Addendum 1 for RFB927920-01

Project Name: WRC Decentralization Phase 2 & Fire Alarm & Myers Hall Sprinkler
DAS RFB #: 927920-01
DAS Project #: 9279.20-21 & 9294.00
Date: 2/16/2023

C6 BASEMENT MECHANICAL PIPING DEMOLITION PLAN
1/8" = 1'-0" 0 12'

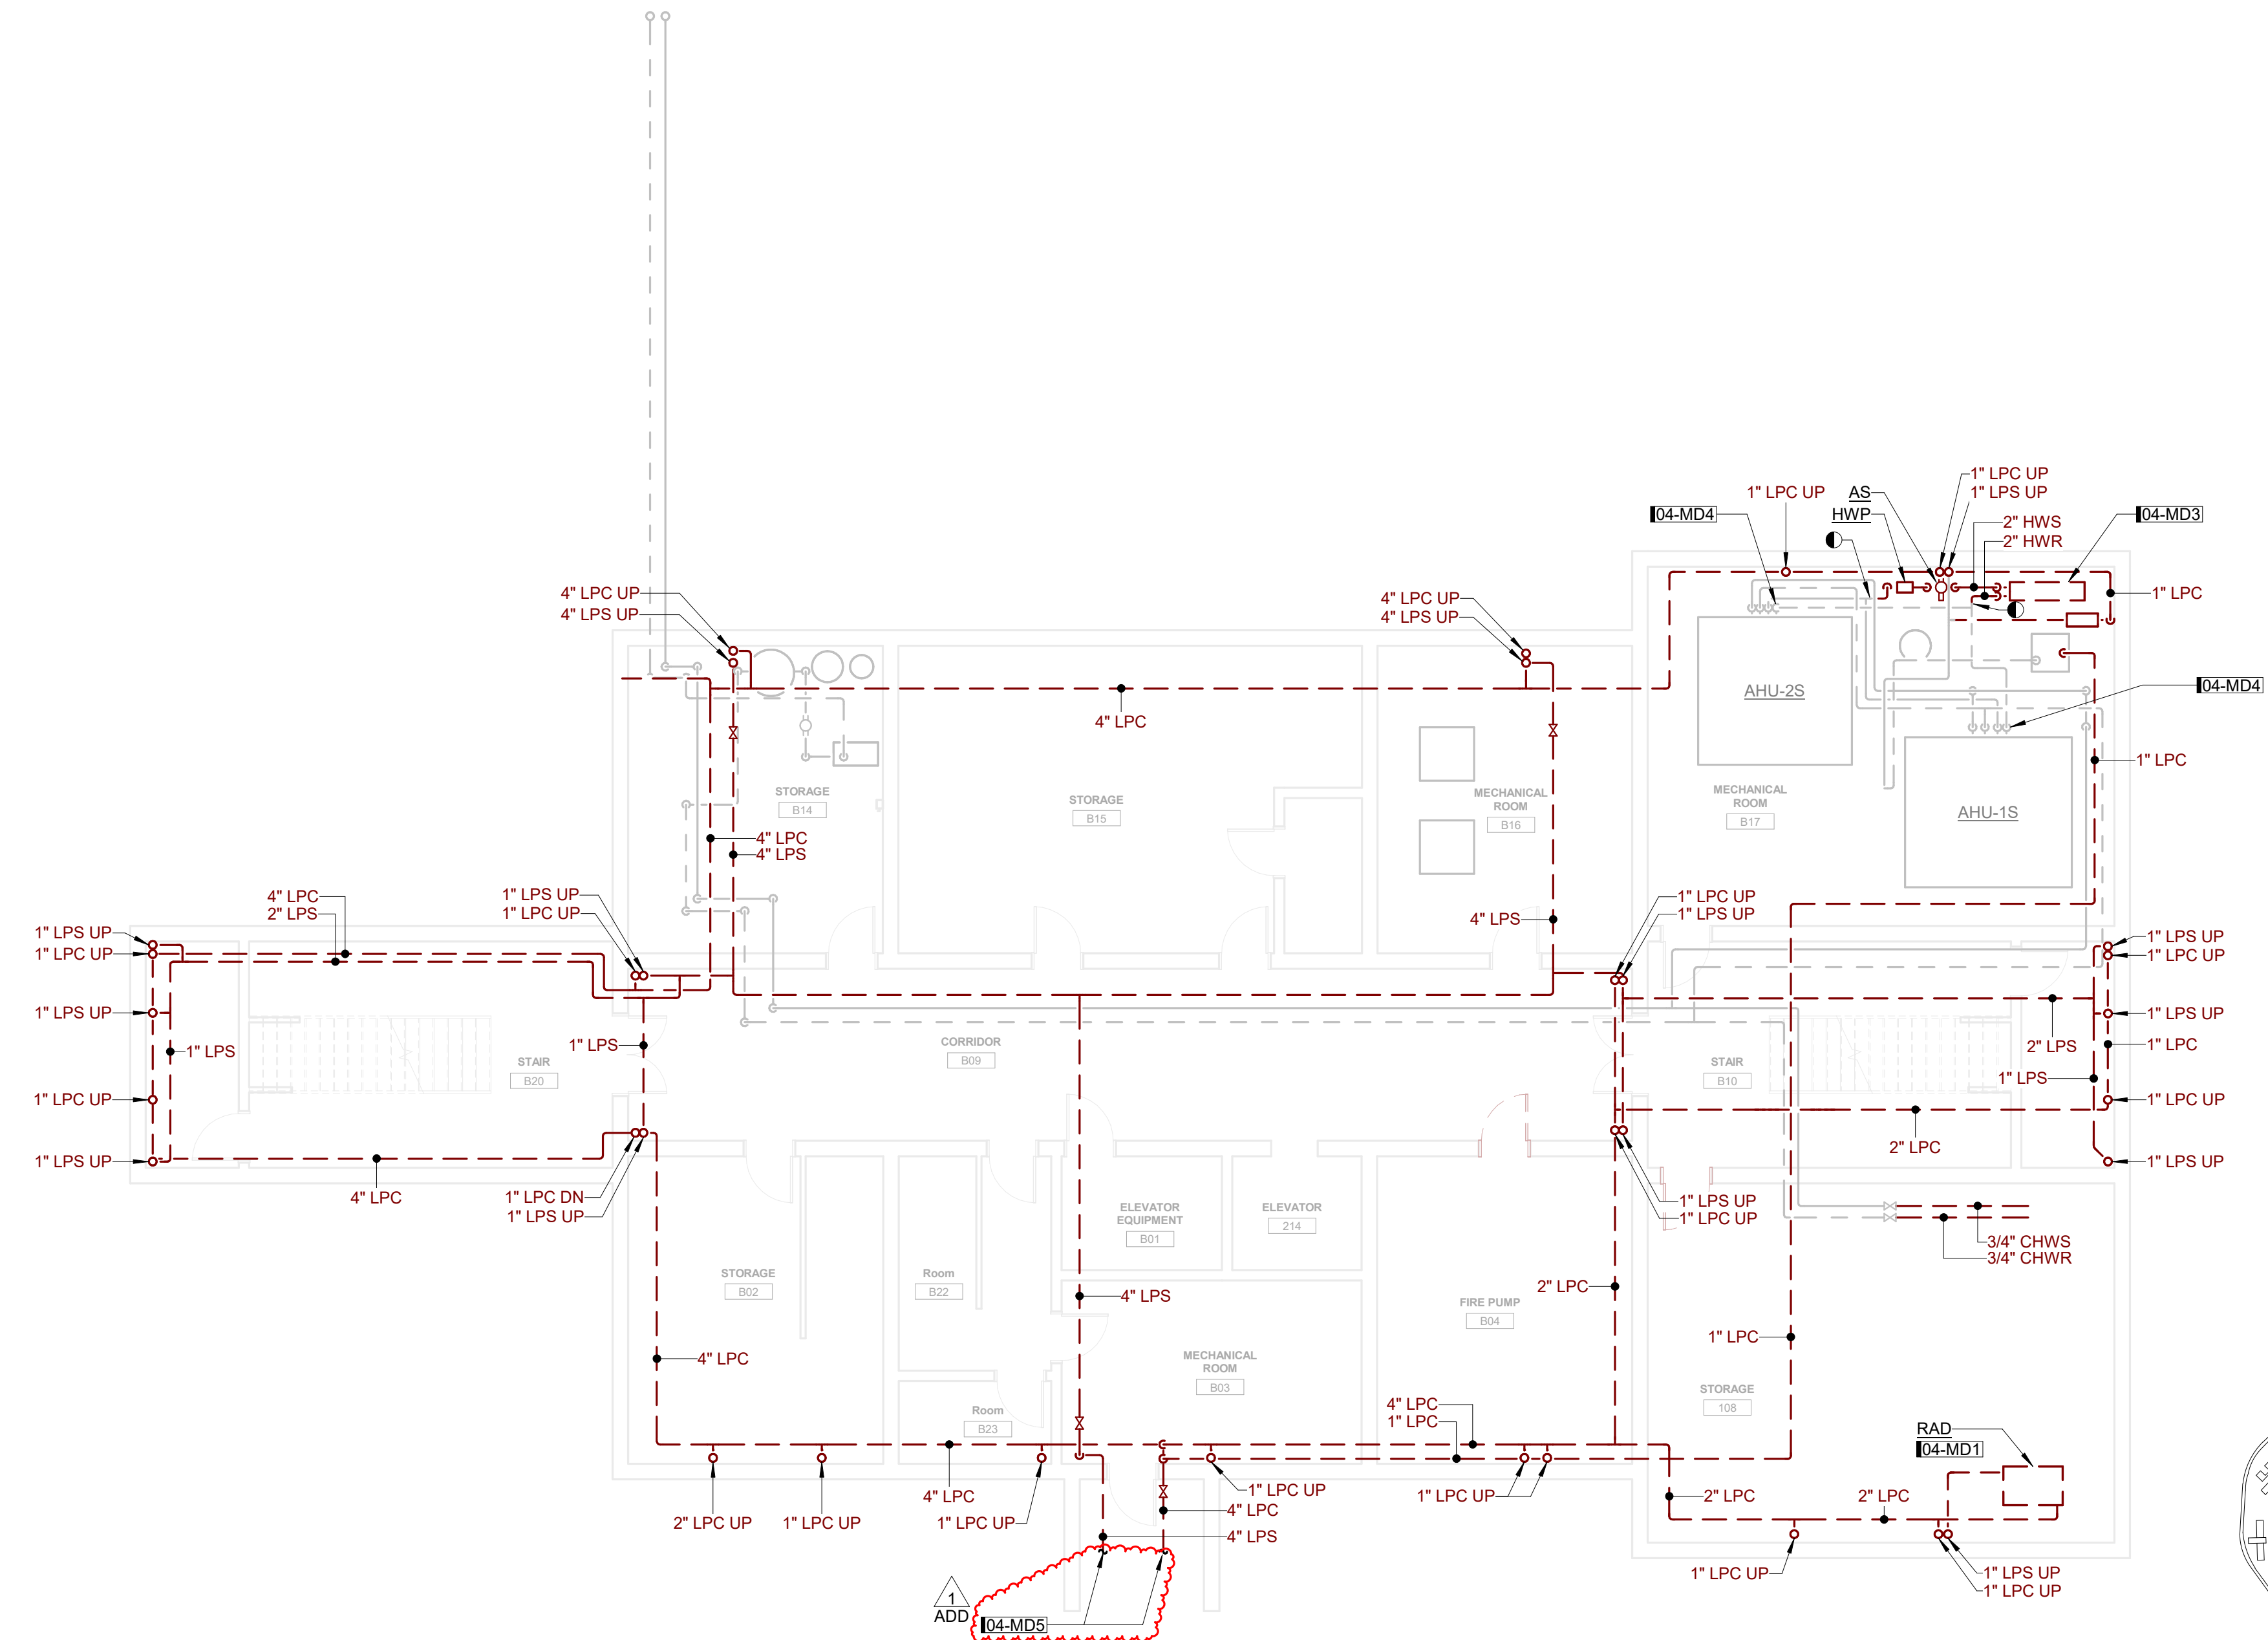
- **ADD** dry sprinkler riser to FIRE PUMP PLAN.
- **04-MD100 – BASEMENT MECHANICAL PIPING DEMOLITION PLAN**
 - **ADD** keynote 04-MD5 regarding demolition of steam piping. See attached sheet for further information.

5 Pot Feeder Piping Detail
NOT TO SCALE

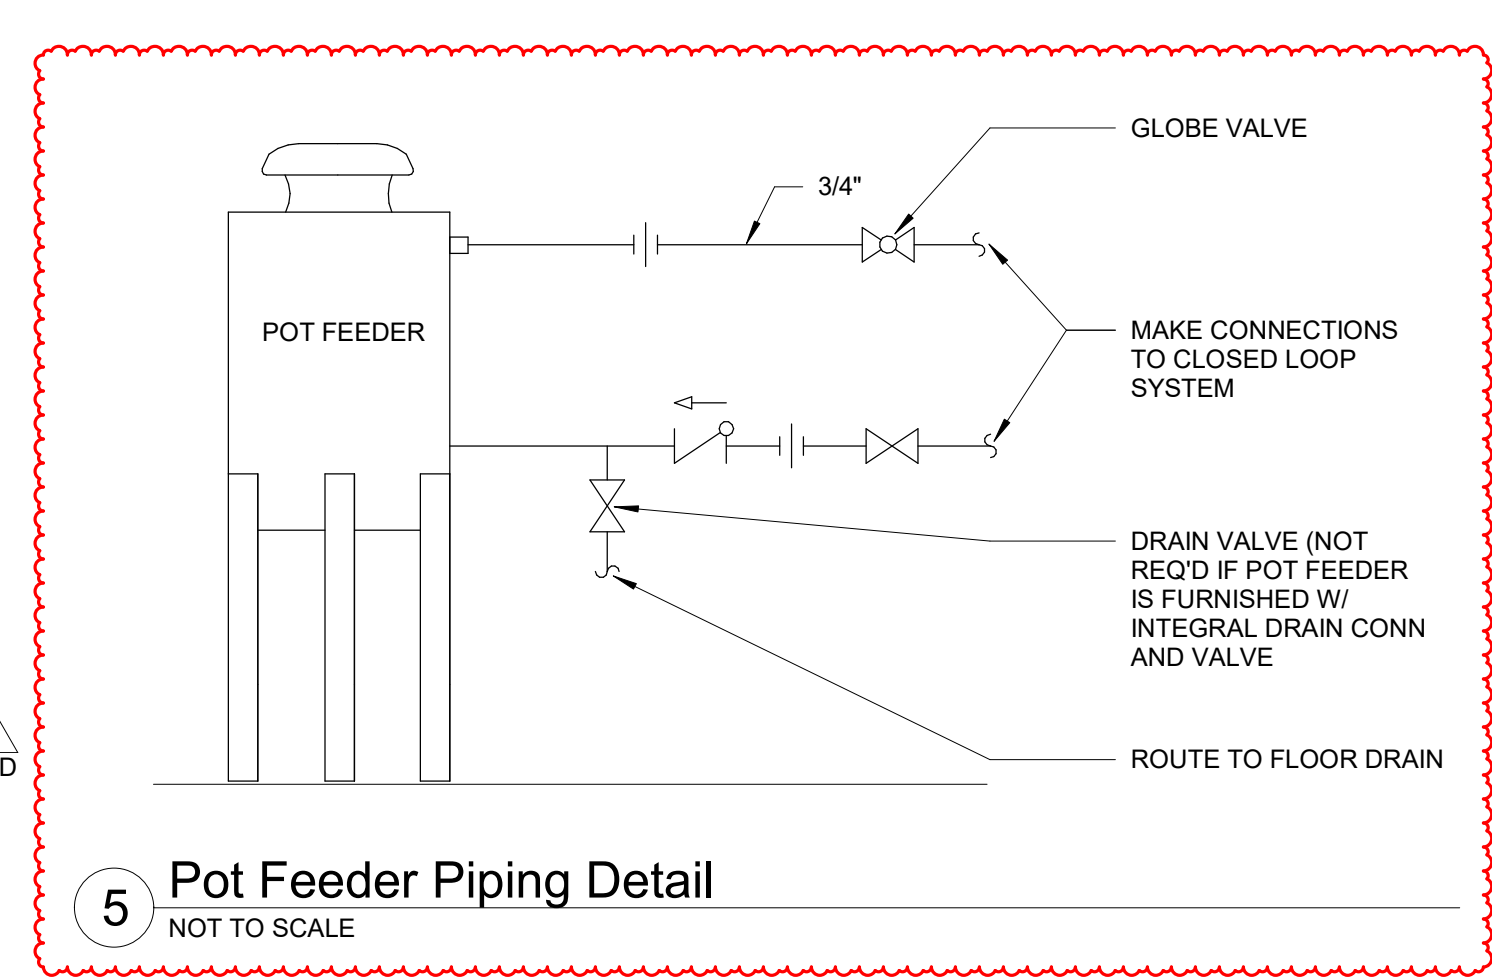
- **04-M100 – BASEMENT MECHANICAL PIPING PLAN**
 - **ADD** keynote 04-M05 regarding exhaust fan.
- **04-M500 – MECHANICAL DETAILS**
 - **REVISE** details F6 and D6 to read (heating water) instead of (chilled water). The intent is for the detail to apply to all heating water piping. Added detail 5 regarding pot feeder piping detail.
